**HARTZELL PROPELLER INC.**  
**SERVICE BULLETIN**  
**HC-SB-61-401**  
**5D31-NK366B1( ): 107373-2 Spring Guide**

- (1) Hartzell Propeller Inc. is introducing the 107373-2 spring guide as a replacement for the 107373 spring guide used in the affected propellers.
  - (a) Incorrect orientation of the asymmetrical 107373 spring guide has been shown to affect the beta ring response due to low spring return force.
  - (b) The symmetrical 107373-2 spring guide can be installed in either orientation.

**Spring Guide Removal/Installation**  
**Figure 1**

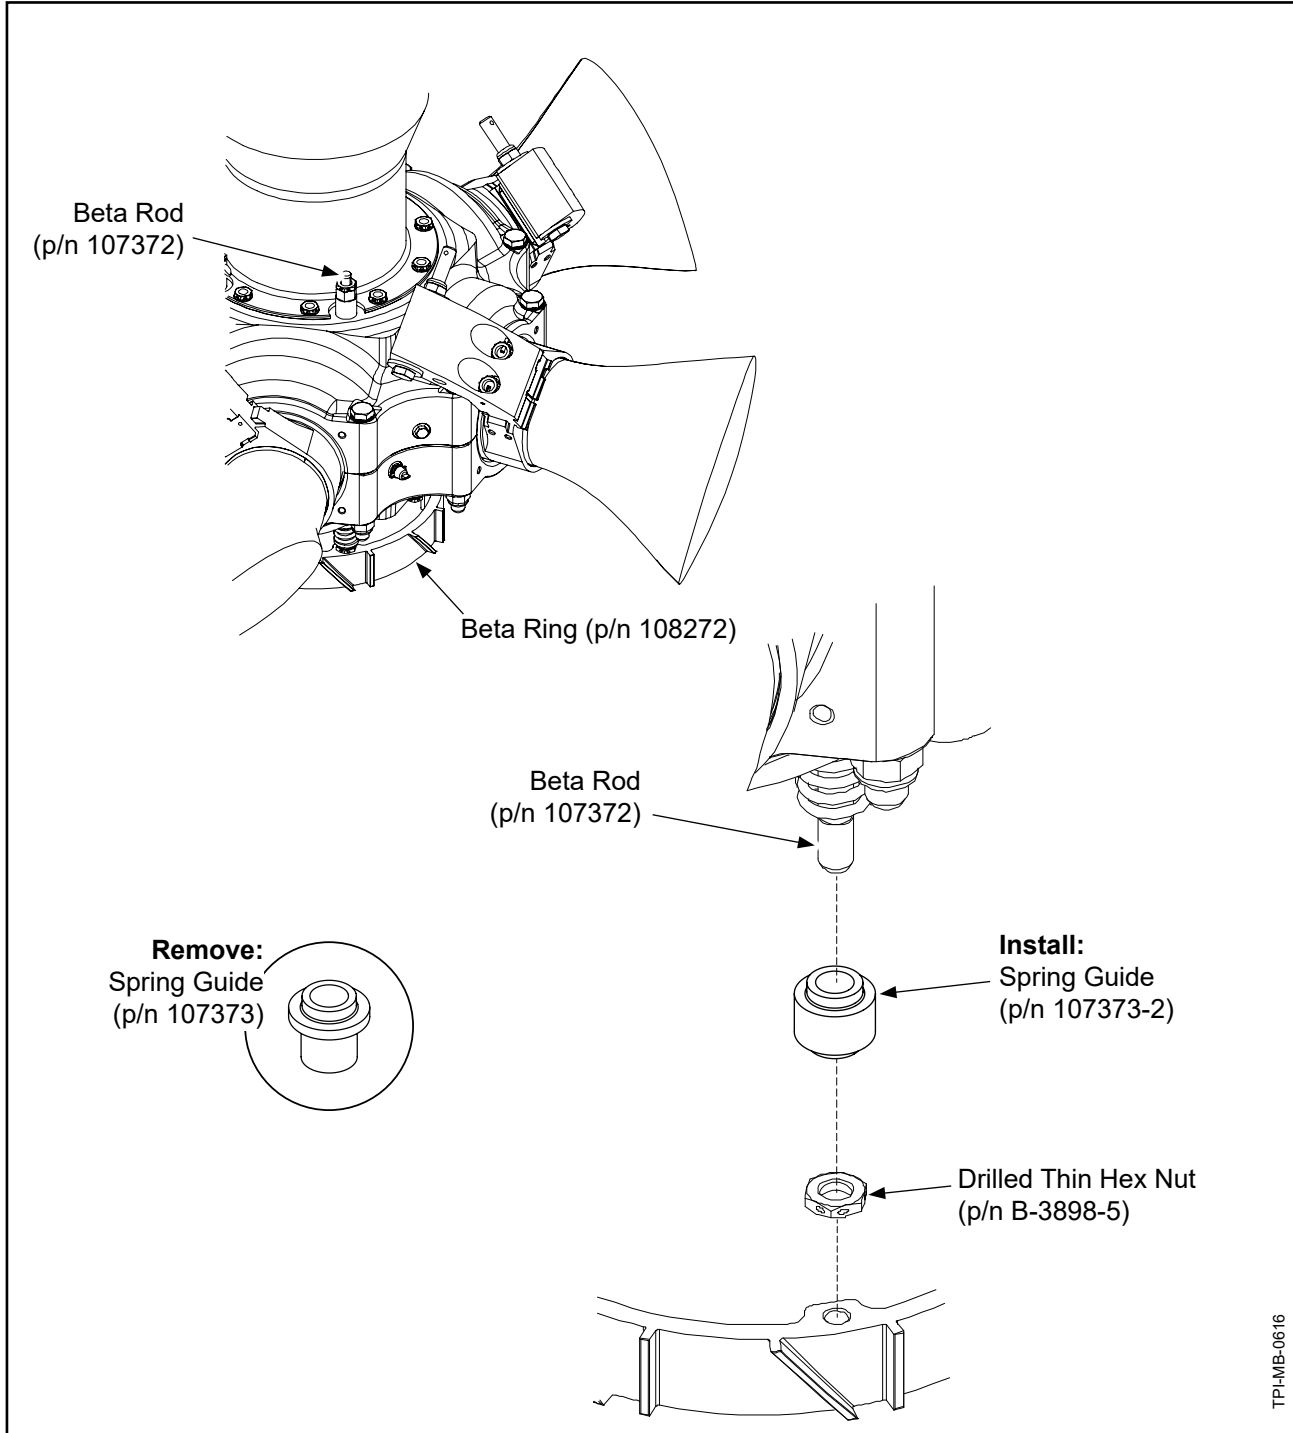
- (1) Remove the propeller from the aircraft in accordance with Hartzell Propeller Inc. Owner's Manual 486 (61-00-86) and Chapter 61 in the Daher TBM 960 AMM.
- (2) The following steps in this procedure must be performed by a certified propeller repair station with the appropriate rating.
- (3) Remove the three 107373 spring guides (p/n 107373) in accordance with Figure 1 and the following steps:
  - (a) Loosen the three drilled thin hex nuts (p/n B-3898-5).

- (b) Using a 1/4 inch open-ended wrench on the flats at the cylinder-end of the beta rods (p/n 107372), turn the three beta rods out of the beta ring (p/n 108272).
  - (c) Remove the beta ring from the beta rods.
  - (d) Remove the drilled thin hex nuts and spring guides.
- (4) Install three 107373-2 spring guides in accordance with Figure 1, then install the drilled thin hex nuts.

- (5) Install the beta ring onto the beta rods in accordance with Figure 1 and the following steps:
- (a) Using a 1/4 inch open-ended wrench on the flats at the cylinder-end of the beta rods, turn the three beta rods into the beta ring until the beta rods bottom out in the threaded holes of the beta ring.
  - (b) Back each beta rod out of the beta ring by rotating one turn.
- (6) Check the beta ring height/OD run-out in accordance with the instructions in this Service Bulletin.
- (7) Set/check the low pitch blade angle in accordance with the instructions in this Service Bulletin.
- (8) Install the propeller onto the aircraft in accordance with Hartzell Propeller Inc. Owner's Manual 486 (61-00-86) and Chapter 61 in the Daher TBM 960 AMM.
- (9) Make an entry in the propeller logbook indicating the 107373-2 spring guide was installed in accordance with this Service Bulletin.

**Beta Ring Height/Run-out  
Figure 2**

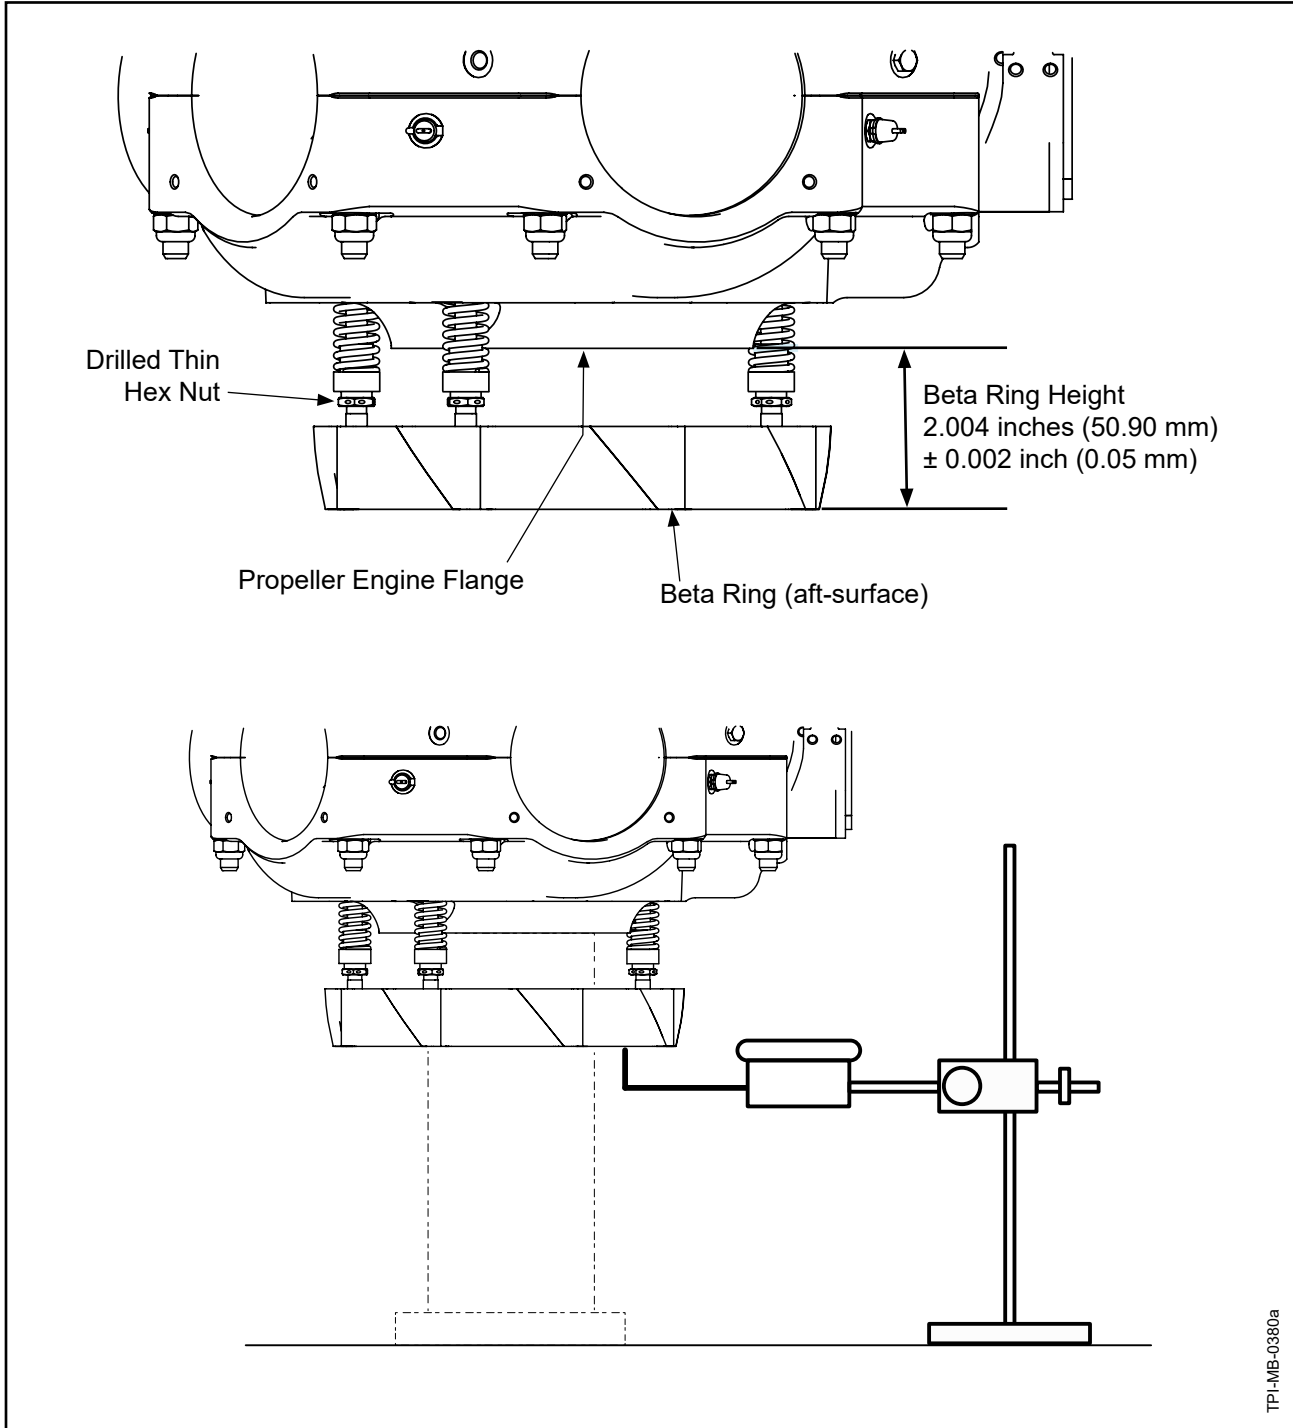
- (1) Using a depth micrometer, measure the height of the beta ring.
  - (a) Beta ring height is measured from the aft surface of the beta ring to the propeller engine flange surface. Refer to Figure 2.

- (2) Using a dial indicator on the aft-surface of the beta ring, check the height run-out of the beta ring. Refer to Figure 2.
  - (a) The height run-out of the beta ring must be within 0.004 inch (0.10 mm).

- (b) Set the height of the beta ring to 2.004 inches (50.90 mm)  $\pm 0.002$  inch (0.05 mm).
  - (c) Adjust the height by rotating the beta rods clockwise to decrease or counterclockwise to increase.

**Beta Ring OD Run-out  
Figure 3**

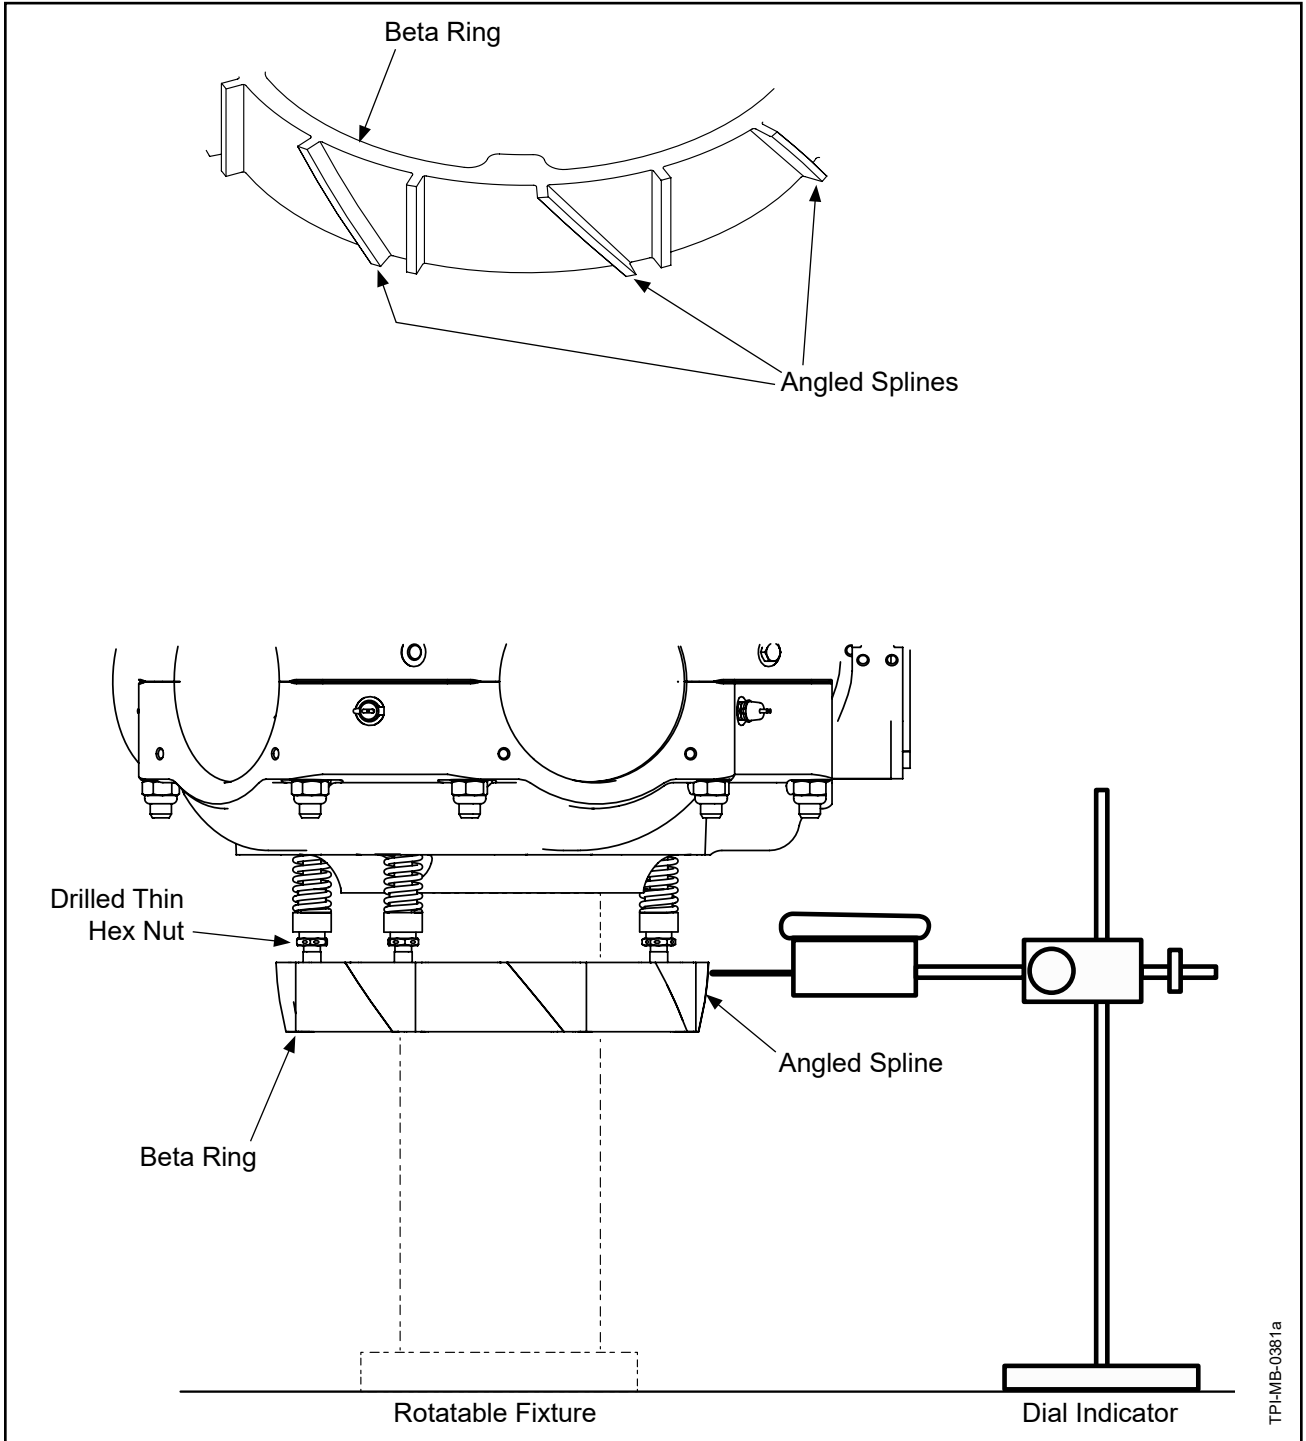
- (3) Using a dial indicator on the angled splines of the beta ring, check the OD run-out of the beta ring. Refer to Figure 3.
  - (a) The OD run-out of the beta ring must be within 0.015 inch (0.38 mm).

- (4) Torque the drilled thin hex nuts 108-132 In-Lbs (13-14 N•m) against the beta ring.
- (5) Measure the height of the beta ring and the run-out (height and OD). Correct as necessary. Refer to Figure 2 and Figure 3.

**Setting/Checking Low Pitch Blade Angle**  
**Figure 4**

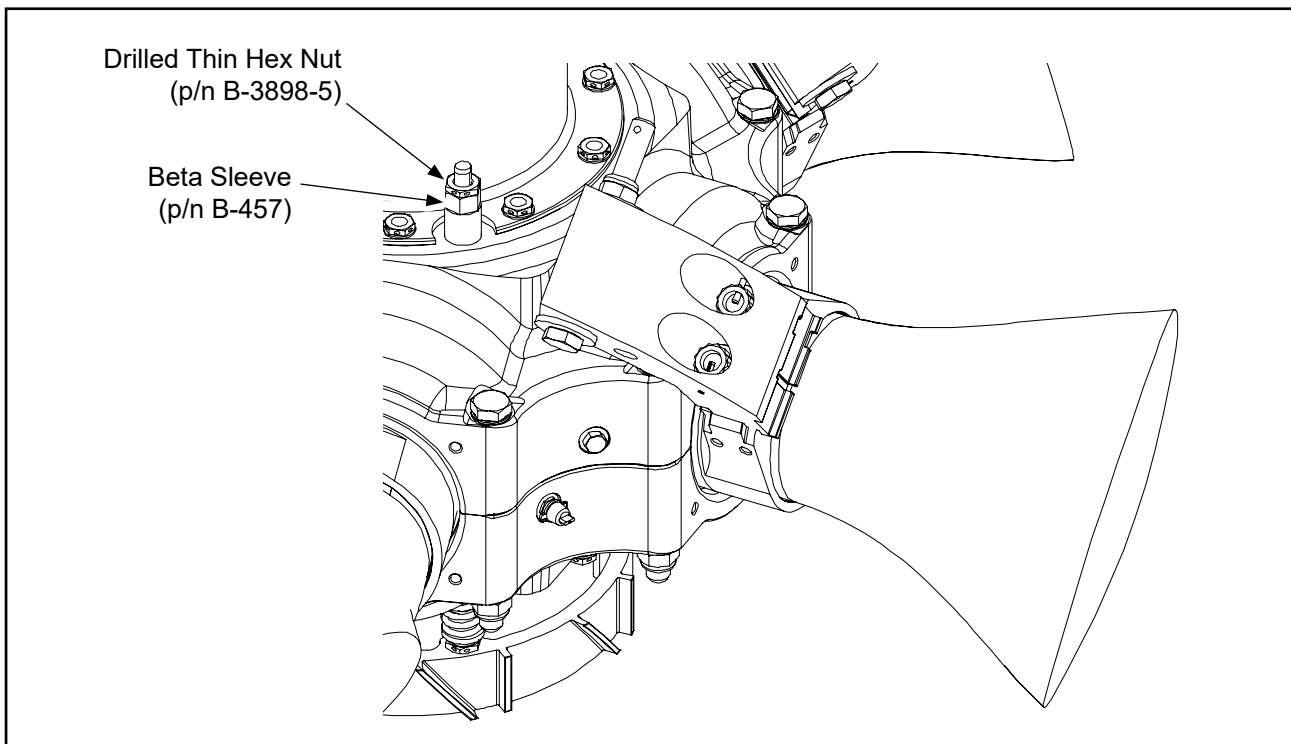
- (1) Refer to the applicable Aircraft Type Certificate Data Sheet or Hartzell Propeller Inc. Application Guide Manual 159 (61-02-59) for the specific low pitch blade angle and reference blade radius required
- (2) Pressurize the propeller to the low pitch blade angle.
  - (a) Lock the air pressure into propeller to maintain the low pitch blade angle.
- (3) Rotate each beta sleeve (p/n B-457) into the hub until it touches the fork plate (p/n 106067 - not shown). Refer to Figure 4.
- (4) Tighten the drilled thin hex nuts (p/n B-3898-5) against the beta sleeves. Refer to Figure 4.
  - (a) Torque the drilled thin hex nuts to 108-132 In-Lbs (13-14 N•m).
- (5) Release the air pressure, then repressurize the propeller to the low pitch blade angle.

**NOTE:** The beta sleeves and fork plate should just contact.

- (6) Recheck the low pitch blade angle and adjust the beta sleeves if required.
- (7) Apply 200 psi (13.78 bars) air (or oil) pressure to the propeller.
- (8) With the propeller in full reverse, check the run-out of the beta ring in accordance with the step below:
  - (a) Using a dial indicator on the aft-surface of the beta ring, check the height run-out of the beta ring. Refer to Figure 2
    - 1 The height run-out of the beta ring must be within 0.004 inch (0.10 mm).
- (9) Correct if necessary by readjusting the beta sleeves.
- (10) Recheck the low pitch and correct as necessary.
